MEMORANDUM

Reference: Case No. PD-270-RBN, The Avenue at Denton Tap, a zoning change request from Commercial to a Planned Development to allow 29 multifamily units and 8,575 square feet of office/retail uses on 1.77 acres of property located at the northwest corner of Southwestern Boulevard and South Denton Tap Road.

STAFF REPORT

CASE NO. PD-270-RBN, The Avenue at Denton Tap

Site Plan

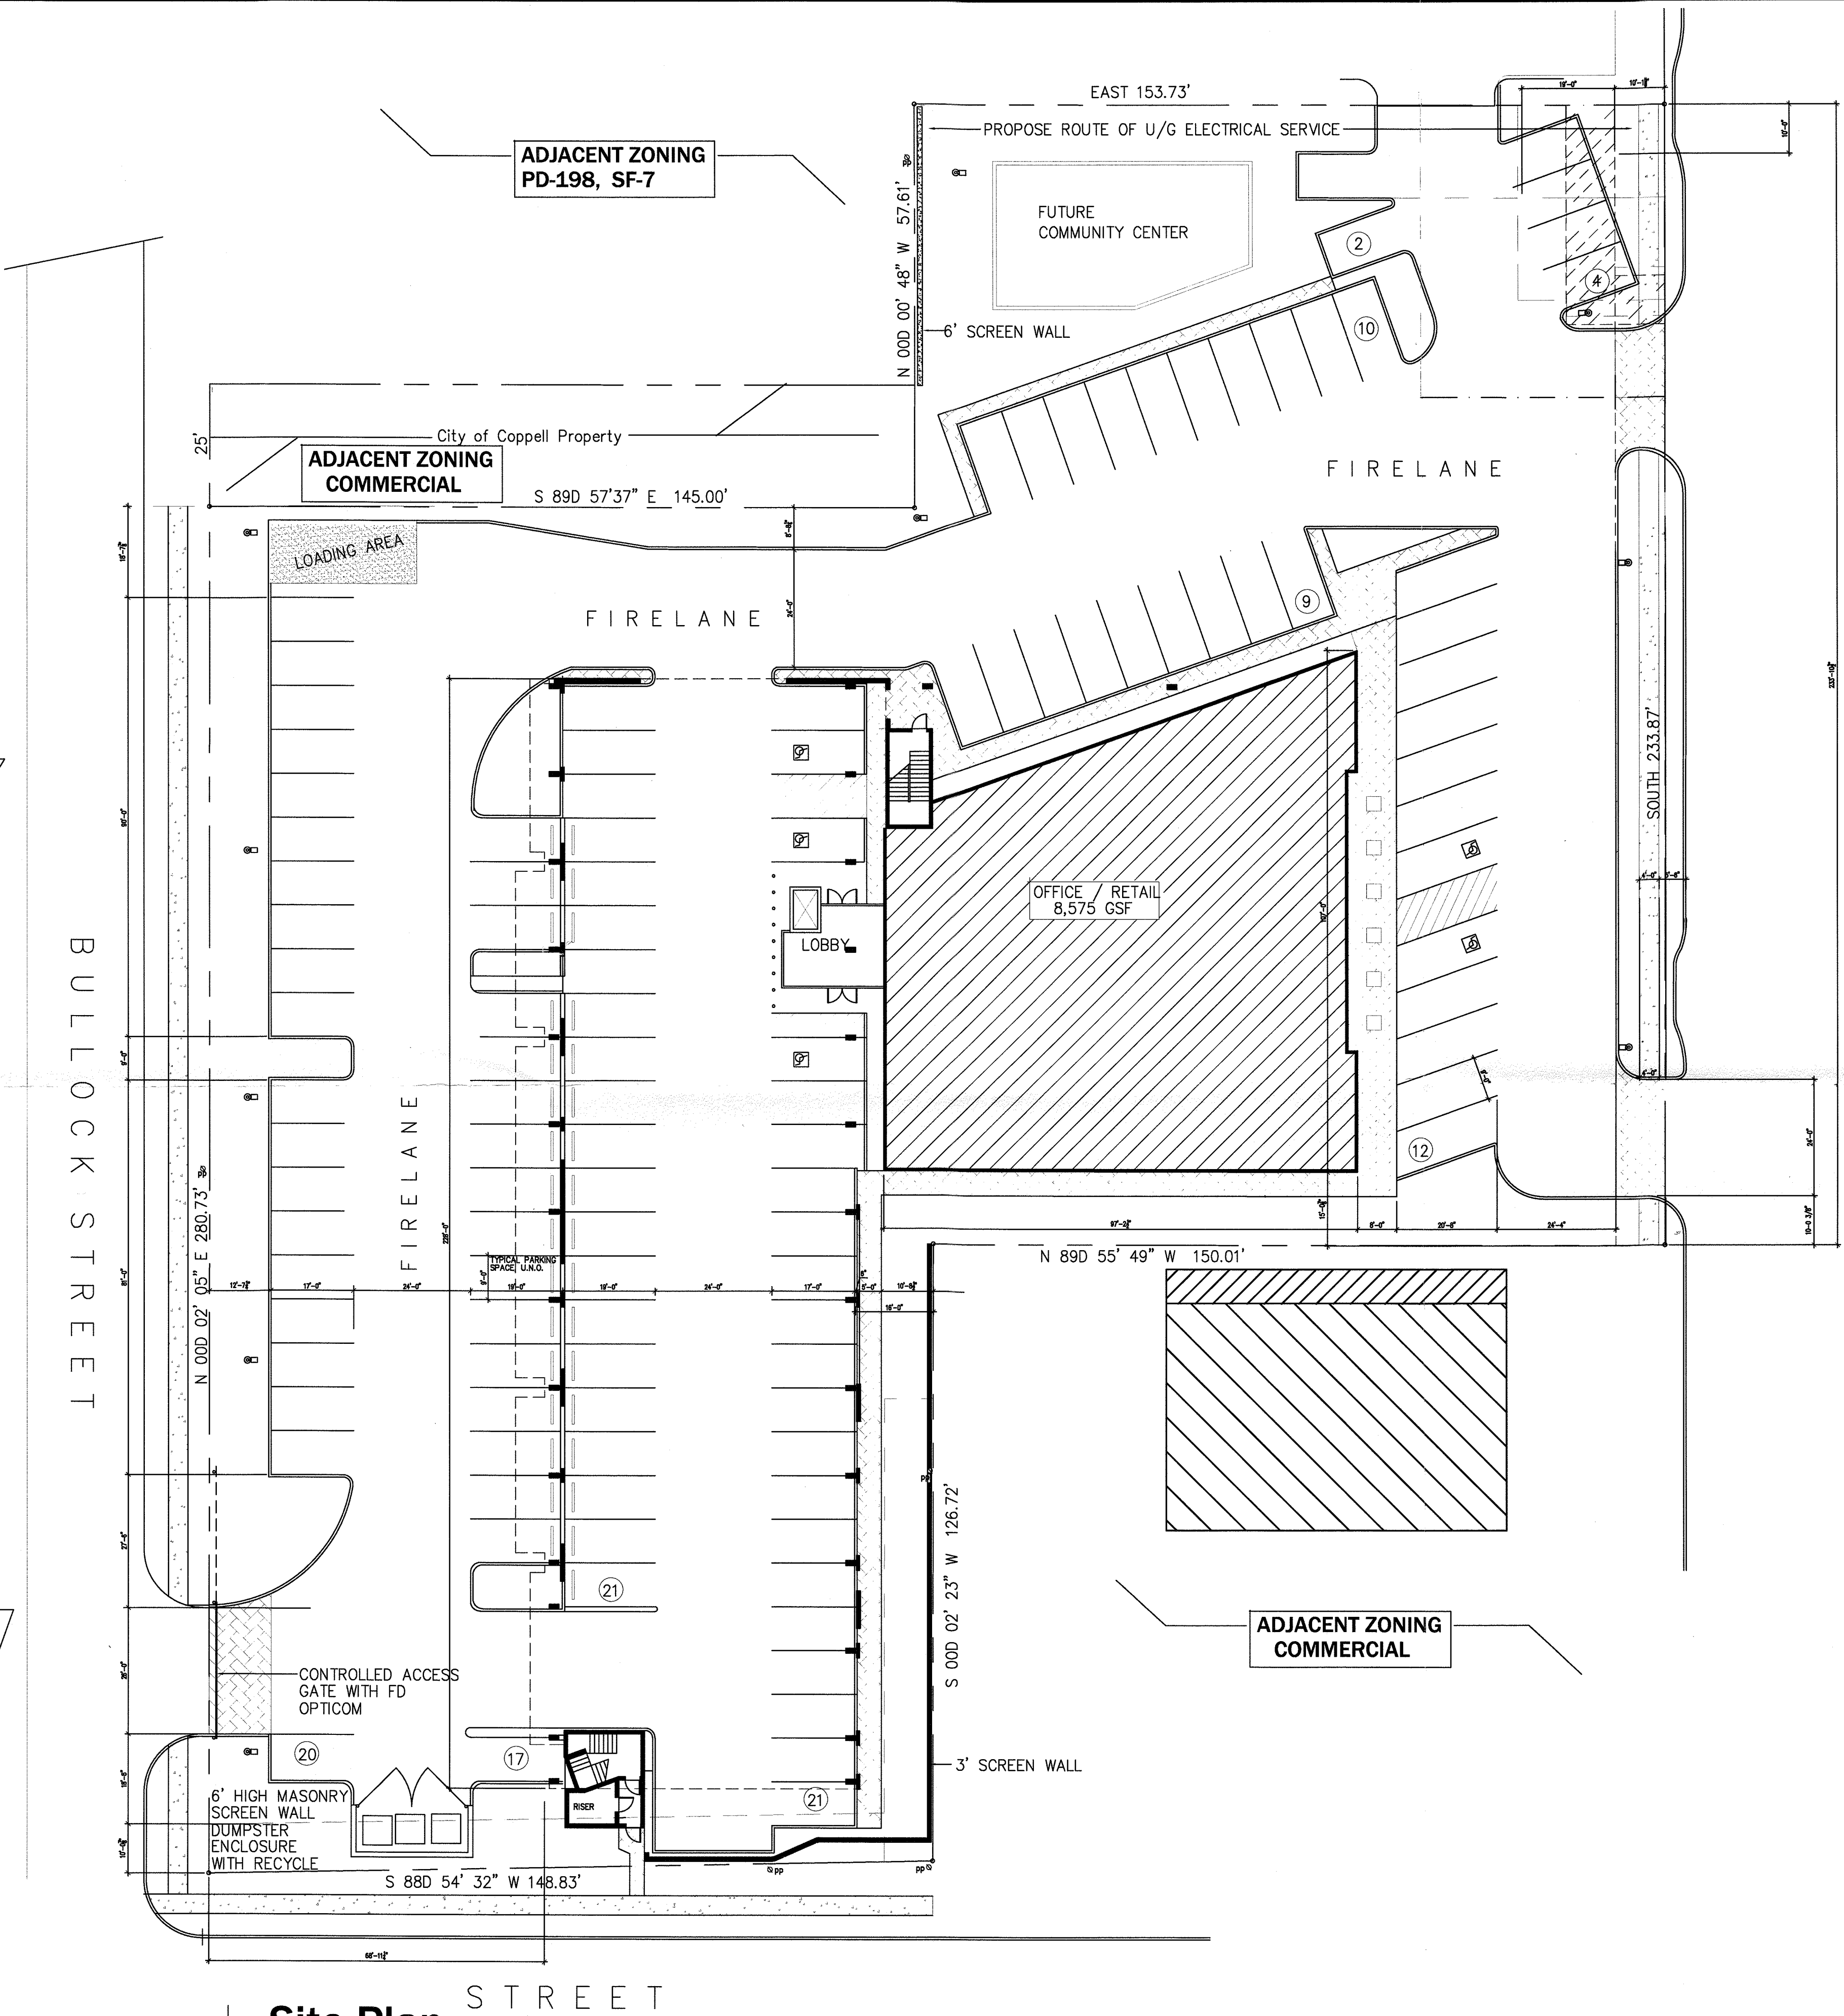
This building is proposed to be setback 63 feet from Denton Tap Road and 69 feet from Bullock Street. It is recommended that the 69-foot setback be supported to keep a buffer and transition from the residential neighborhood into the proposed higher intensity mixed use development.

A 36-foot setback is proposed along the northwest property line, which is adjacent to a 25-foot right-of-way providing a greater separation from the residential neighborhood. The main building is 63 feet from the Denton Tap Road right-of-way where the RBN District calls for a building to be no more than 15 feet from the lot line. Staff can support this deviation, as both a drive and parking are warranted for the office/retail use.

This proposal exceeds the 116 parking space requirement by providing 119 spaces. Both the *Comprehensive Plan* and the RBN District encourages structured (garage) parking. In this development 41 of the 119 spaces are contained within the structure. It is recommended that this parking area on the first floor be better screened with a three-foot masonry wall incorporated into each façade and this has

been listed as a condition of approval. Beyond the structured parking are 41 spaces in a parking lot. This area is proposed to be screened with a 12 foot wide landscaped area east of Bullock Street. The proposed off-street parking and drive (similar to a slip street recognized in the Comprehensive Plan). The proposed parking located on the Denton Tap Road side is angled with a one-way drive to provide an opportunity for streetscaping without actually having dangerous on-street parking on Denton Tap.

1. Additional Comments will be generated during detailed Engineering Plan Review.
2. Minor Plat approval is required prior to obtaining a building permit.
3. Park fees of \$1,285 per unit shall be paid prior to building permit.
4. Draft property owners association documents are required to be submitted for attorney review and filed at the time of plat recordation if units are sold individually.
5. Submit Future Community Center plans to the Director of Planning for administrative review, prior to permitting or construction.

1 LANDSCAPE PLAN
SCALE 1"=20'

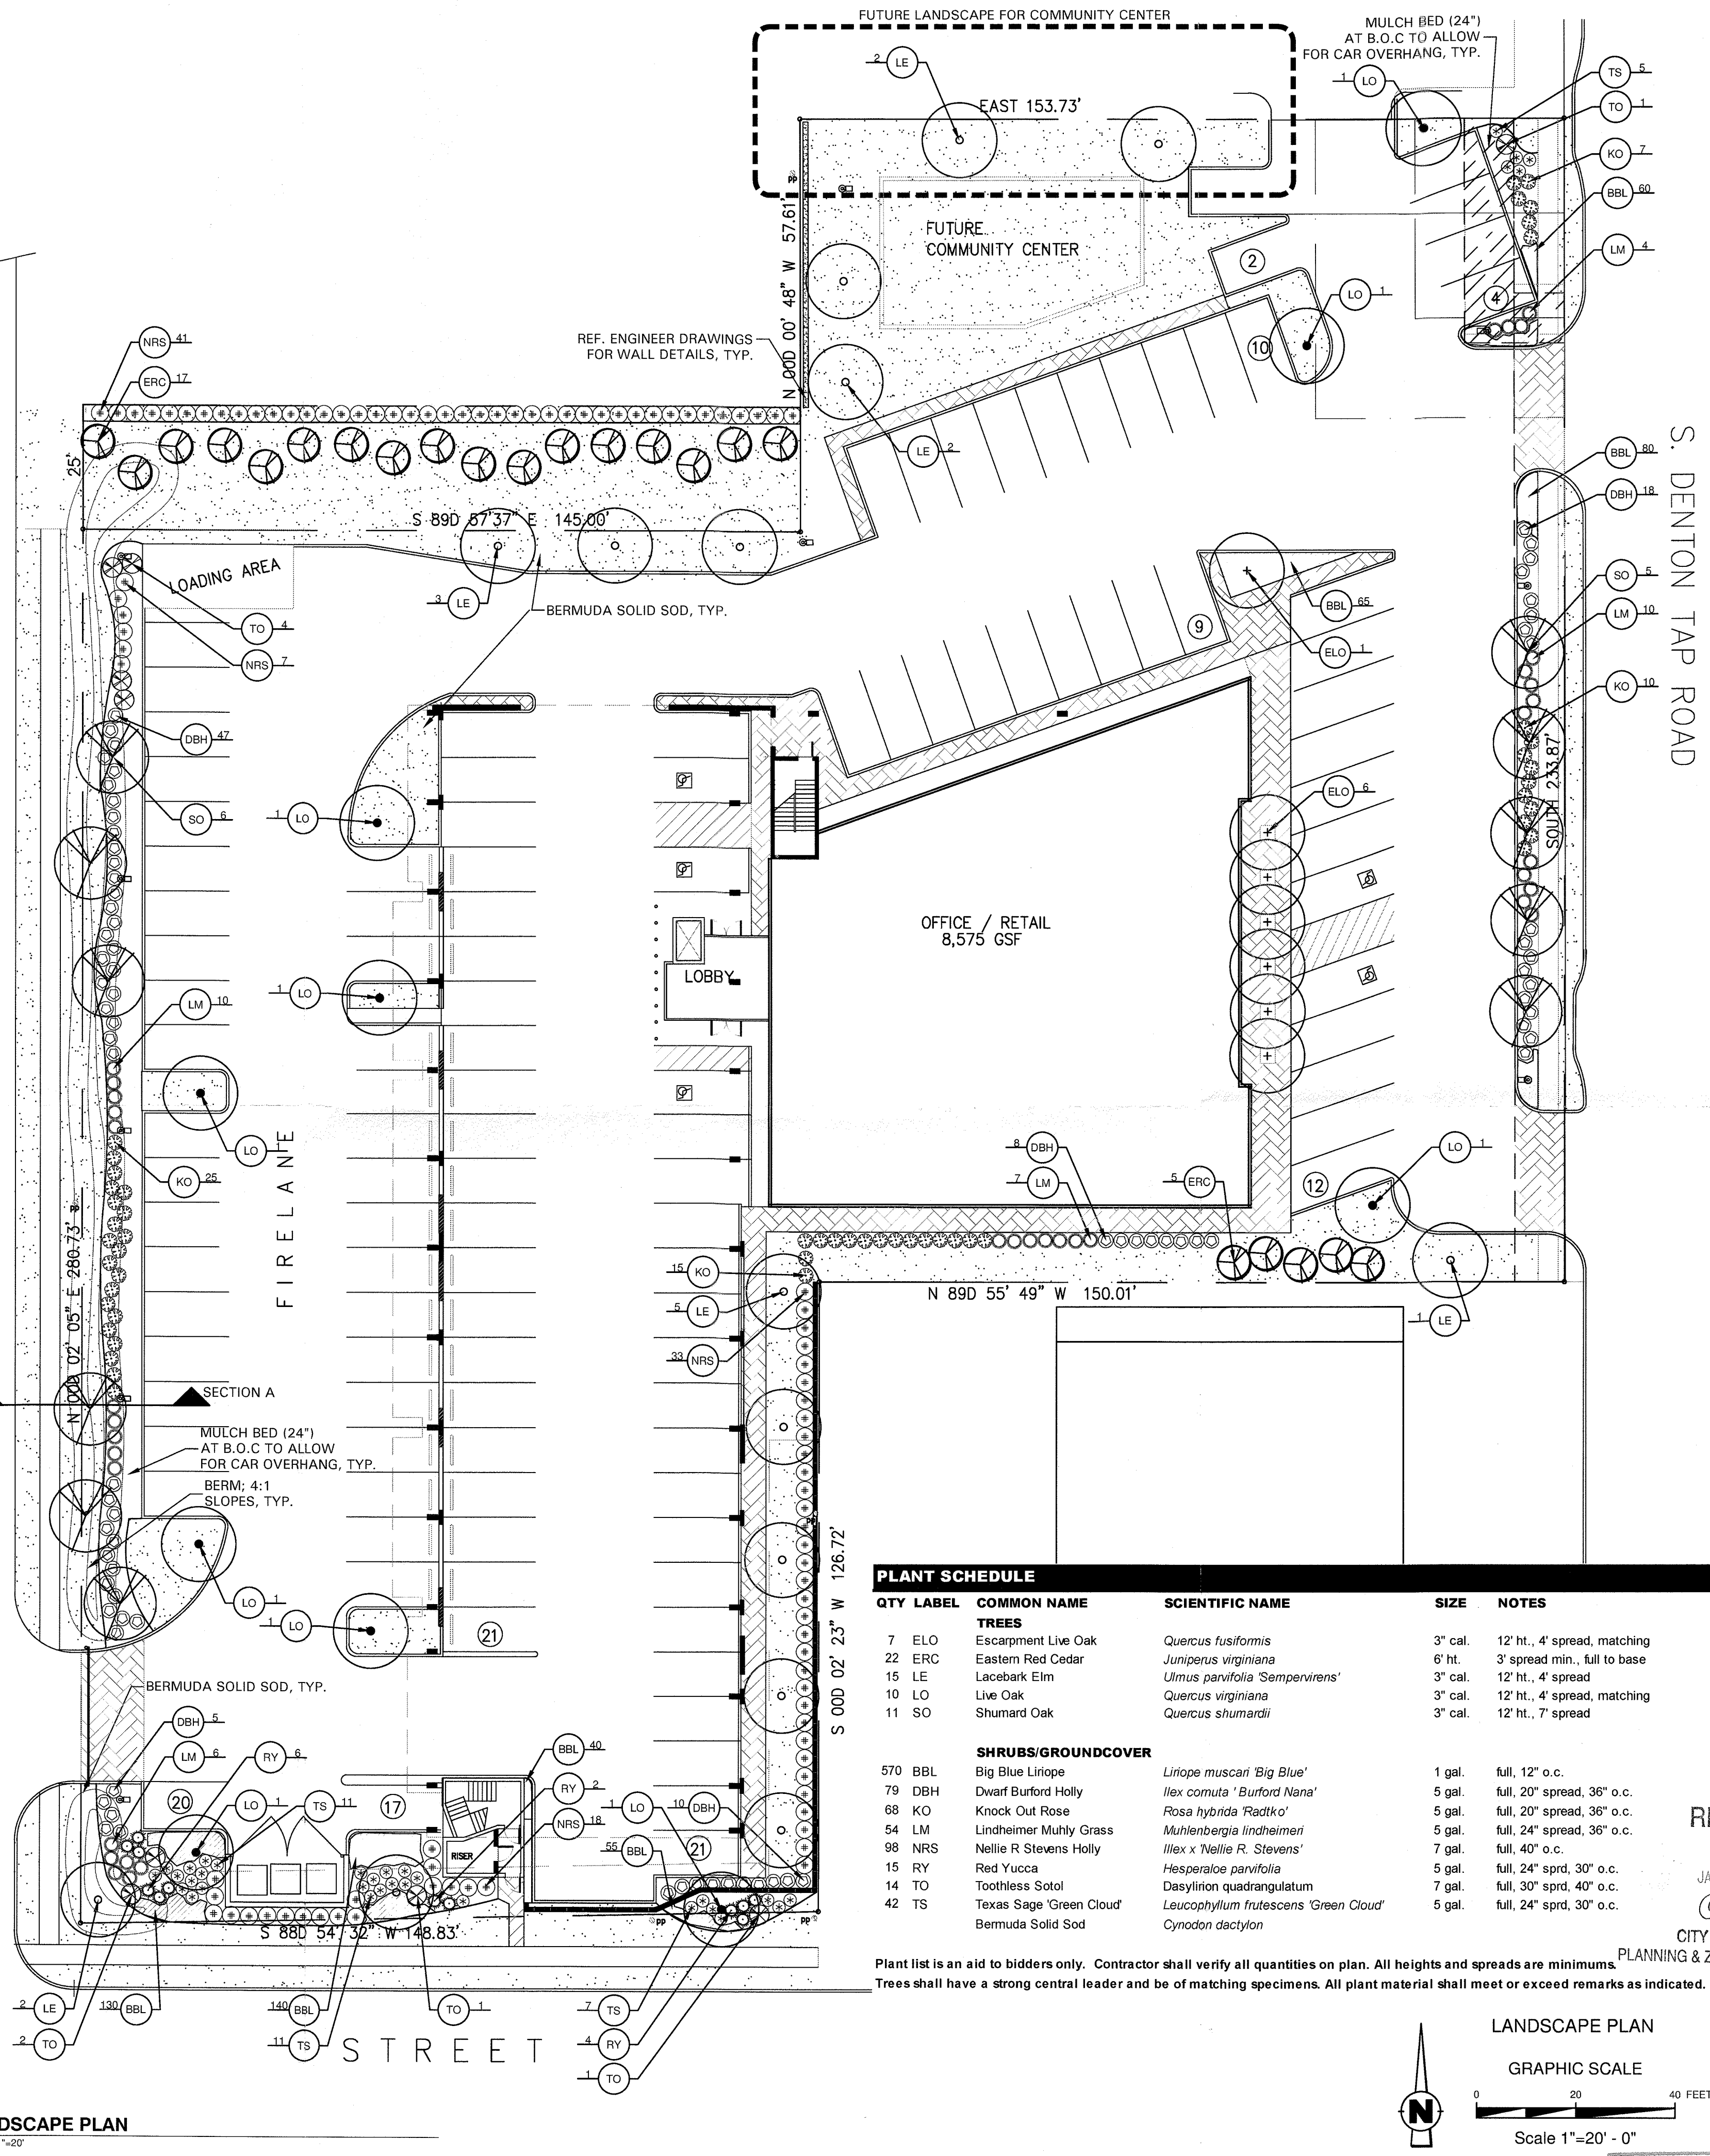
The landscape areas within a RBN District are different than the typical business zoning districts where under the RBN, a minimum 15% open space/common area is required. The proposal indicates that 17% has been provided. The streetscaping of the retail/office area is adequate where street trees are being provided. However, additional landscape islands are being recommended in the parking lot where there is no structure over the parking. Not more than 15 parking spaces are typically permitted without an island and one island is required at the end of each parking row; therefore, three islands are recommended. Also, the applicant has agreed to add an evergreen area of landscaping (containing Nellie R. Stevens and Eastern Red Cedars) to the 25 foot right-of-way strip located northwest of the property to better buffer/screen this proposal from the existing residential neighborhood.

| 8. | Include three 150-square-foot landscape islands with an overstory tree within the proposed surface parking area where not under the structure. No more than 15 spaces are typically permitted without an island and one island is required at the end of each parking row. |
| 12. | Label the 25-foot right-of-way northwest of the site as City of Coppell Property. Include Eastern Red Cedars and Nellie R. Stevens south of the existing fence. |
| 15. | Revise the Landscape Plan to include interim and future landscaping for the "Future Community Center" portion of the site. |
